Ozone BV1 Important Notice

IMPORTANT SAFETY NOTICE

Concerning the Ozone BV1 harnesses produced before November 2022.

Original Spec

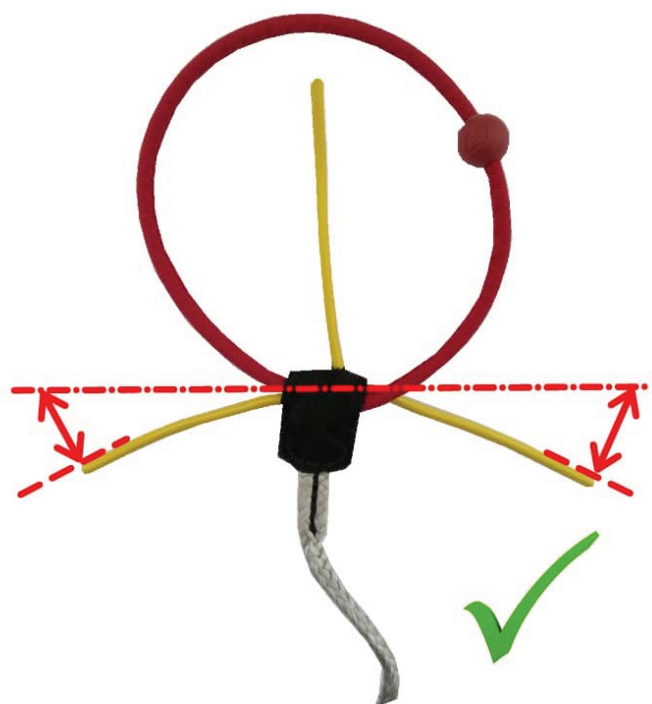
1. Remove the handle from the harness so the pins are extracted from the loops. Bend the horizontal pins to downwards by approximately 30 degrees. No tools are required, the modification is easily made by hand using gentle pressure.

By hand, bend the horizontal pins to the approximate angle shown. Doing so will improve the extraction process
